## Product Change Notice (PCN)

PCN Number: **PCN-0451185R-01**

Product(s) Affected: PJ-050B

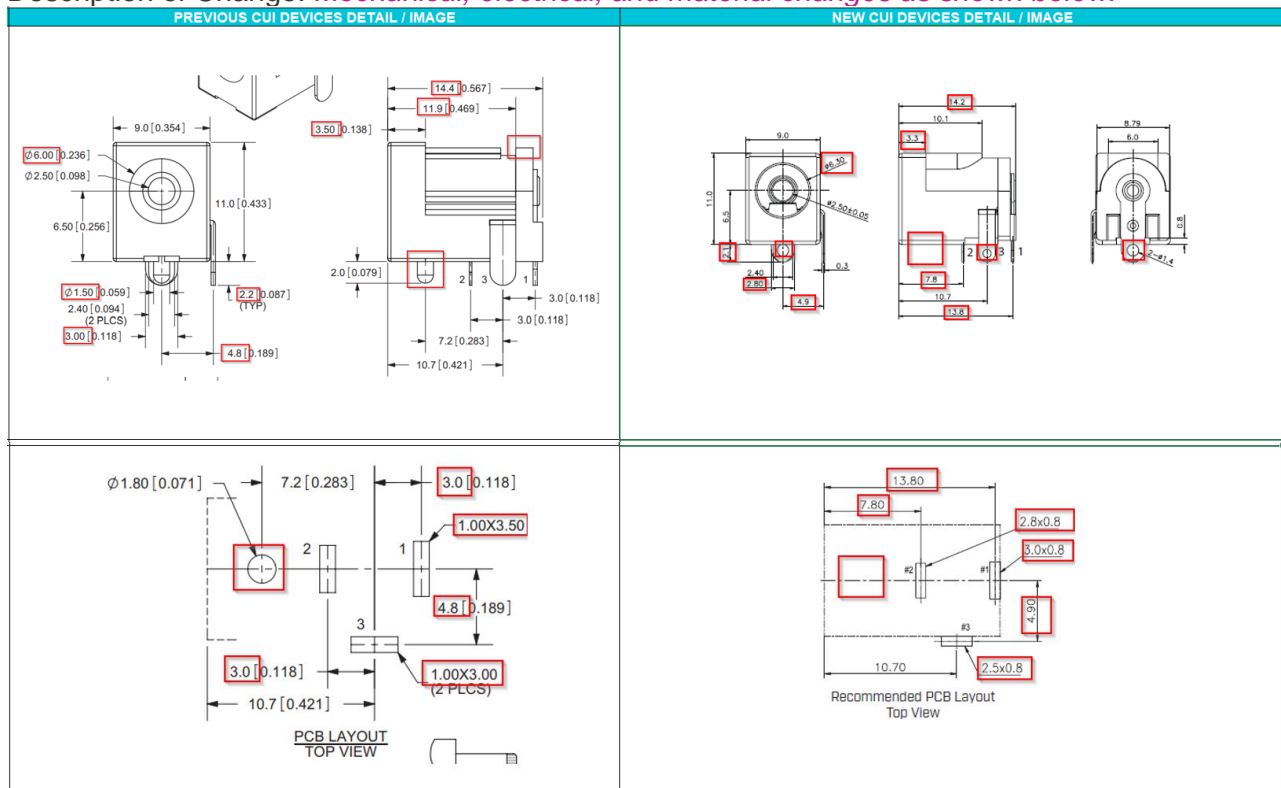
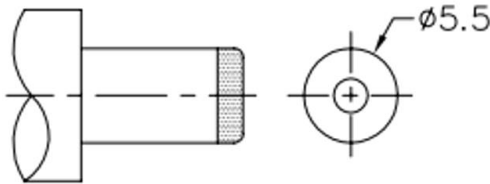
Description of Change: *Mechanical, electrical, and material changes as shown below:*

MATERIAL	PLATING
center pin	copper	nickel
terminal 1	brass	tin
terminal 2	copper alloy	tin
terminal 3	brass	tin
plastic	PBT

DESCRIPTION	MATERIAL	PLATING/COLOR
center pin	copper alloy (H65)	nickel
terminal 1	C2680 t=0.35	nickel-silver
terminal 2	C5210 t=0.25	nickel-silver
terminal 3	C2680 t=0.30	nickel-silver
cover	PA9T UL94V-0	black
housing	PA9T UL94V-0	black

MATING PLUG  
Jack Insertion Depth: 8.5 mm

MATING PLUG  
Jack Insertion Depth: 9.6 mm

Operating temperature range changing to -25C ~ +85C
